## **Incomplete Application Response**

24-101905-PLN | 1441 45<sup>th</sup> Ave NE

PROPOSED IMPROVEMENTS  
FOR: NATURE'S KICK CORP.

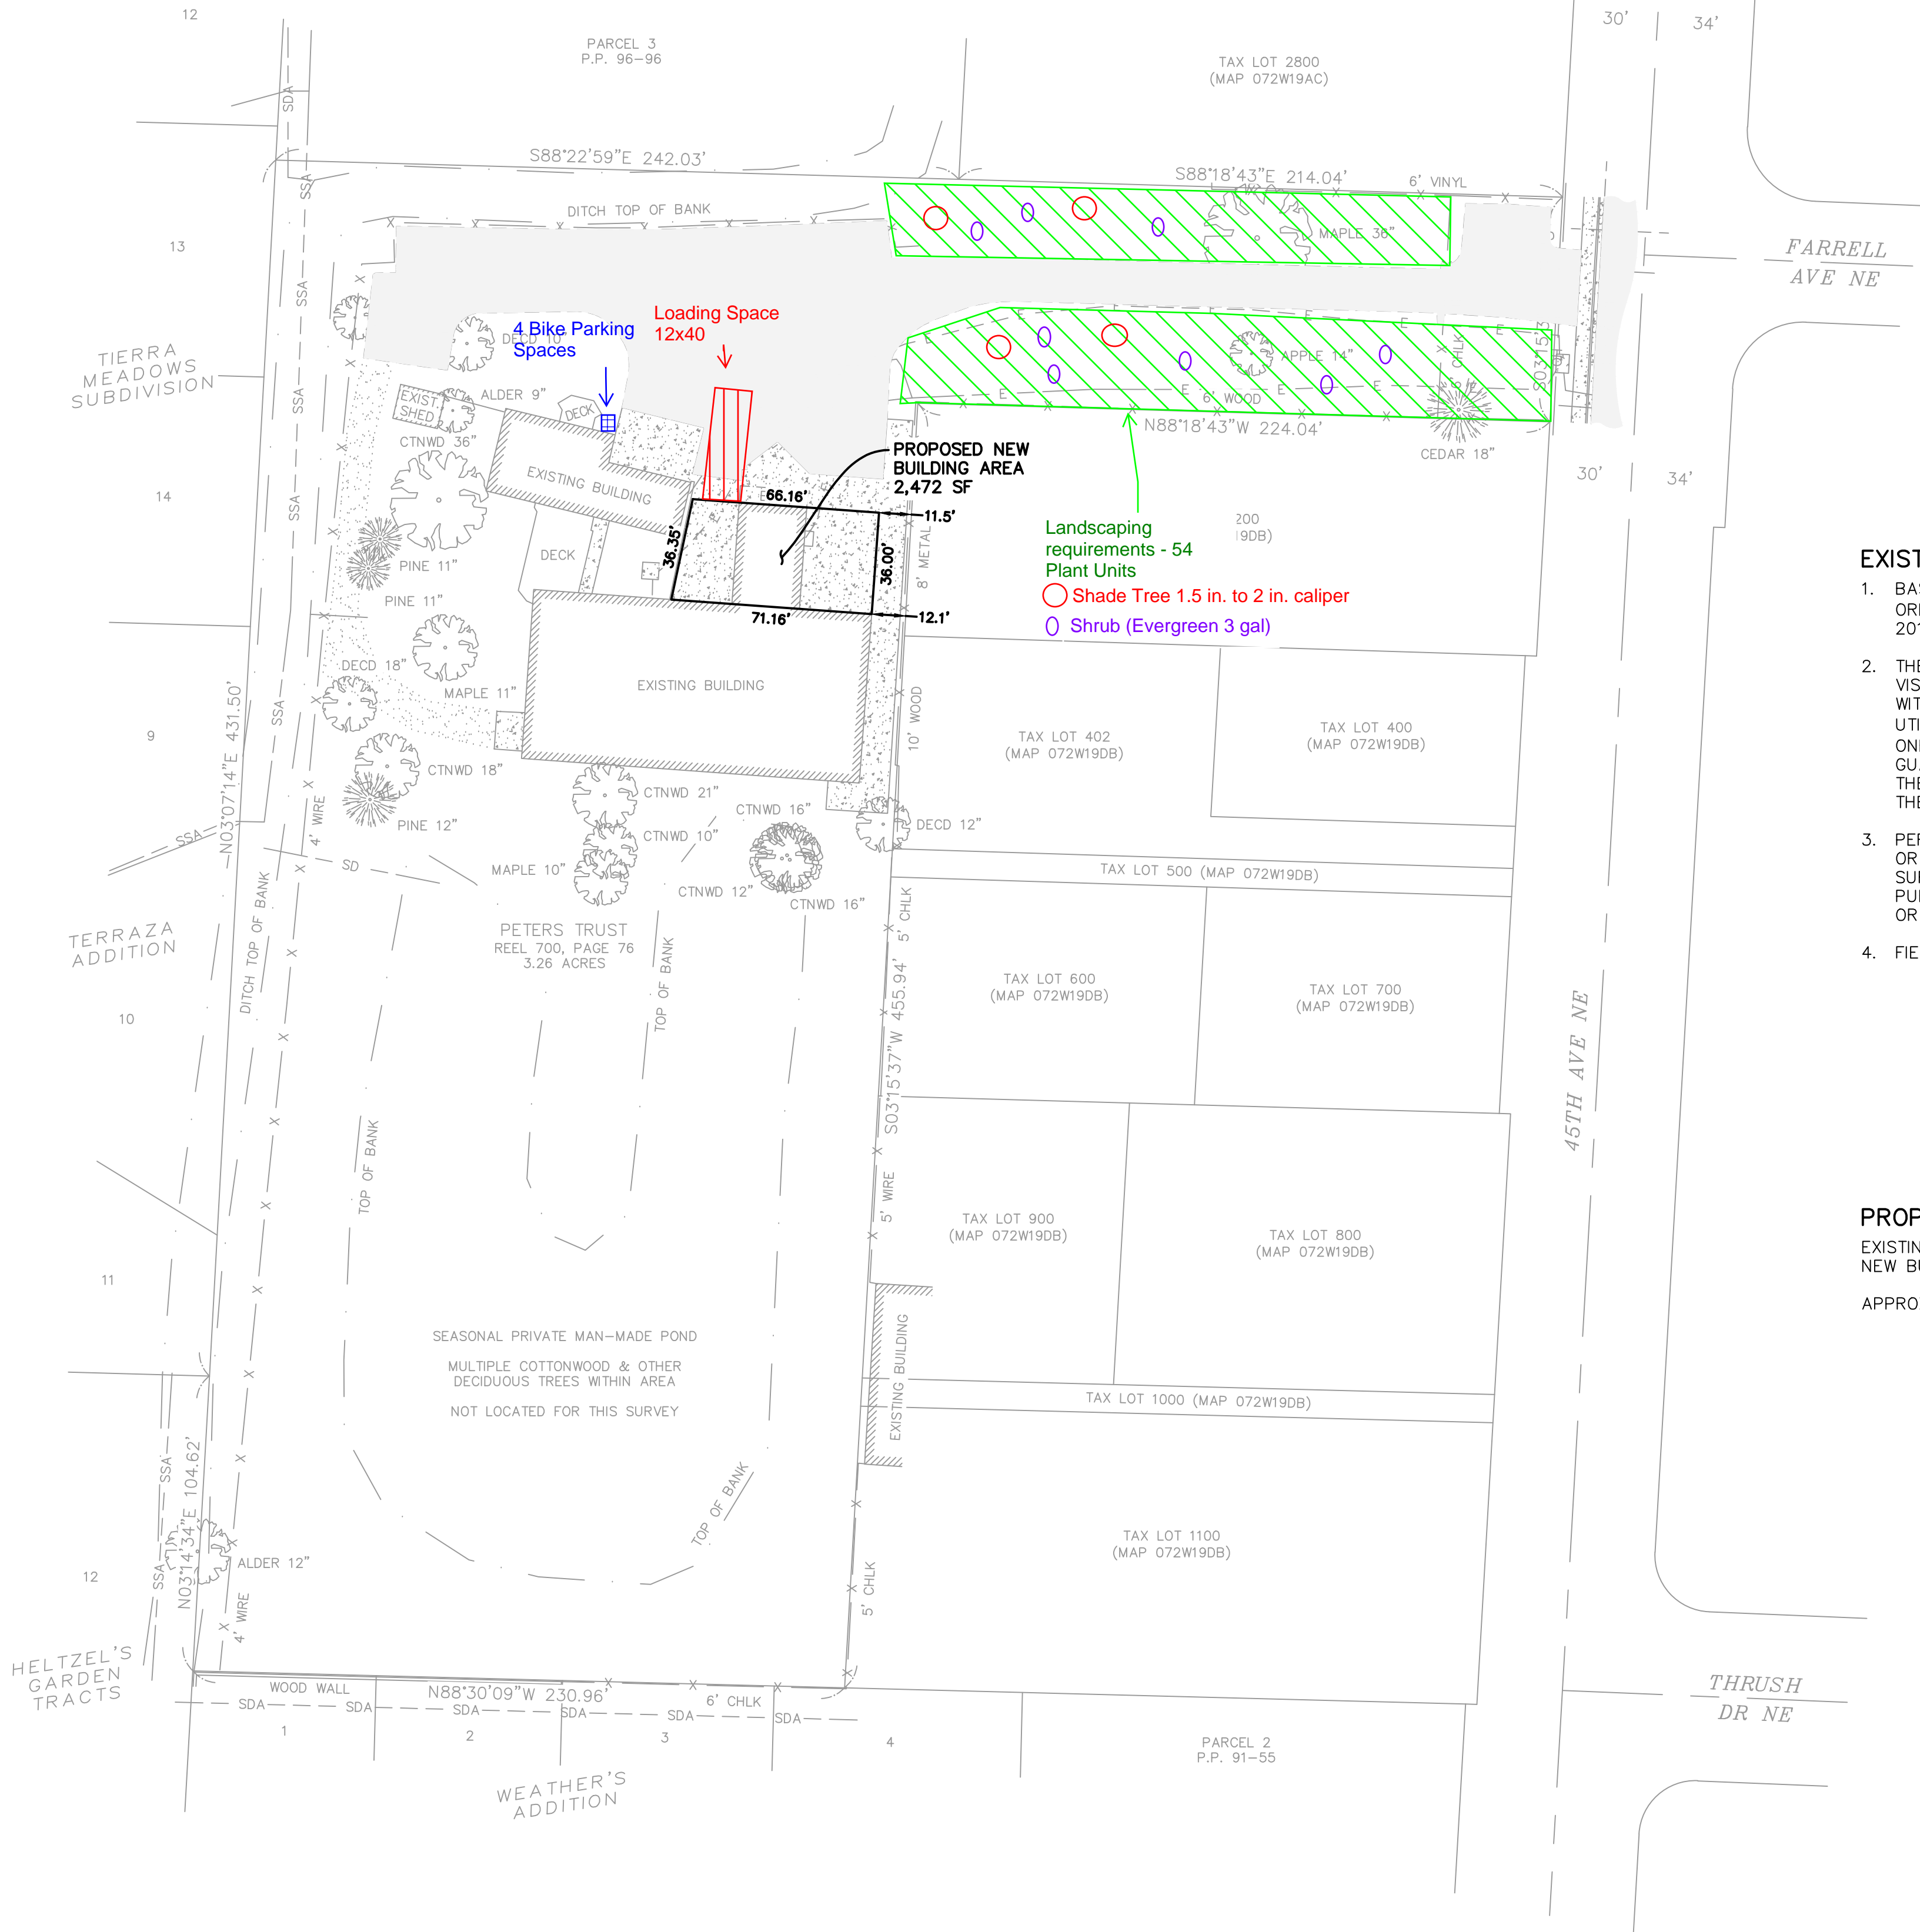
### Item 1: Site Plan.

### Item 3: Adjustment Findings.

Item 10: Existing Conditions Plan.

**Applicant's Response:** *The applicant's parking and loading area has never been striped or indicated on the site. The submitted site plan does provide the location of one loading space as required by SRC 806. The required bike parking is located on the submitted site plan and provides 4 spaces, per SRC 806.060. The existing buildings are used for office, dwelling and storage/warehousing where the honey sticks are manufactured, processed, and shipped out. This has been depicted on the site plan. This item is resolved.*

length of the proposed structure by the 30-foot setback requirement;  $(30 \times 36 = 1,080) - (1,080 / 20 = 54 \text{ P/Us})$ . Type C Landscaping also requires a minimum 6-foot-tall fence or wall; however, the eastern property line has an existing 8-foot-tall sight obscuring fence. By moving the required P/Us from the setback area the applicant is able to enhance the existing landscape areas while still reaching the development goal of adding onto the existing development. The applicant has provided a markup of the proposed location of P/Us, which is attached to this document. This item is resolved.

**Applicant's Response:** The applicant has provided an existing conditions plan. There was an overlay of pavement placed over the existing driveway. In meetings with staff, it was indicated that this was acceptable if any new pavement did not exceed 2,000 square feet. Based on measurements by

applicant and staff the additional pavement does NOT exceed the maximum 2,000 square feet. Therefore, no permit was required. This item is resolved.

The applicant requested the elimination of the landscape screening but has adjusted the request to allow the landscaping and required plant units to be placed at an alternate location on the site. The applicant demonstrates on the attached site plan the number of units required and approximate location. With this the applicant believes that all applicable criteria have been met for this adjustment.
